Access Compliance Report

Public Rights-of-Way

(Curb Ramps)

Intersection ID: 51667	Main Street: HUCKS_RD	Cross Street: SWEETBRIAR_RIDGE_DR	Location:	N
ADA ID: 0B3D46E365A0	Ramp Type: BlendTrans1	Initial Pass/Fail: Fail	Overall Compliance: No	Severity Score: 10

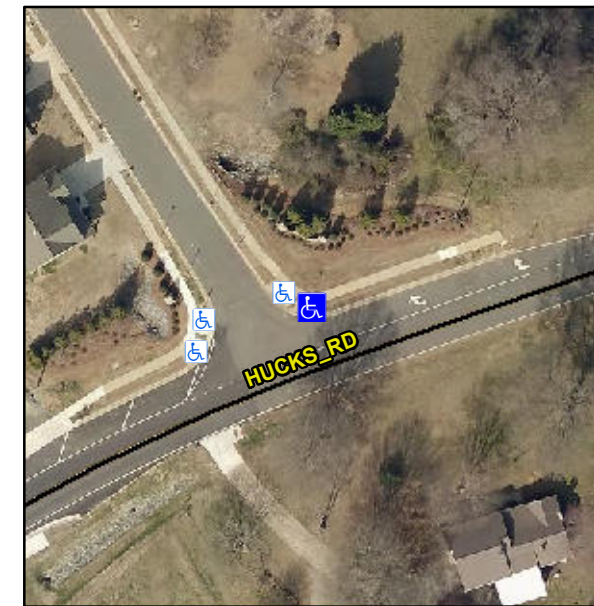
Not Found, R304.5.1, R304.5.3

Compliance	Description	Data	Compliance	Description	Data
N/A	Ramp Length (in)	71.0	Yes	BlendTrans Slope (%)	4.6
No	Ramp Width (in)	47.0	No	BlendTrans XSlope (%)	3.0
N/A	Flare Type LT	N/A	N/A	Flare Type RT	N/A
N/A	Flare Slope LT (%)	N/A	N/A	Flare Slope RT (%)	N/A
N/A	Flare Traversable LT?	N/A	N/A	Flare Traversable RT?	N/A
N/A	Landing Length (in)	N/A	N/A	DWS Provided?	N/A
N/A	Landing Width (in)	N/A	N/A	DWS Contrast?	N/A
N/A	Landing Slope (%)	N/A	N/A	DWS Length (in)	N/A
N/A	Landing X Slope (%)	N/A	N/A	DWS Full Width?	N/A
N/A	Landing Curb? (Y/N)	N/A	N/A	DWS Offset (in)	N/A
N/A	Shared Landing?	N/A			
N/A	Gutter Ponding?	N/A	N/A	Gutter Slope (%)	N/A
N/A	Gutter Lip Ht (in)	N/A	N/A	Gutter X Slope (%)	N/A
N/A	Painted X Walk1?	No	N/A	Painted X Walk2?	N/A
	X Walk 1 Direction	To SE		X Walk 2 Direction	N/A
	X Walk 1 Width (in)	N/A		X Walk 2 Width (in)	N/A
	X Walk 1 Slope (%)	1.5		X Walk 2 Slope (%)	N/A
	X Walk 1 X Slope (%)	2.8		X Walk 2 X Slope (%)	N/A

N/A	Ramp inside XWalk1?	N/A	N/A	Ramp inside XWalk2?	N/A
	Road Slope (%)	2.8		Clear Space?	N/A
	Road X Slope (%)	1.5	N/A	Clear Space to XWalk (in)	N/A
N/A	Any Obstructions?	N/A	N/A	Storm Grate/Utility Hazard?	N/A
	Obstruction Type			Storm Grate/Utility Type	
		N/A			N/A
			Yes	Surface Condition? (G/P)	Good
			No	Curb Slope (%)	18.0

Remove & Replace Curb Ramp With Two New Directional Ramps or Equivalent.
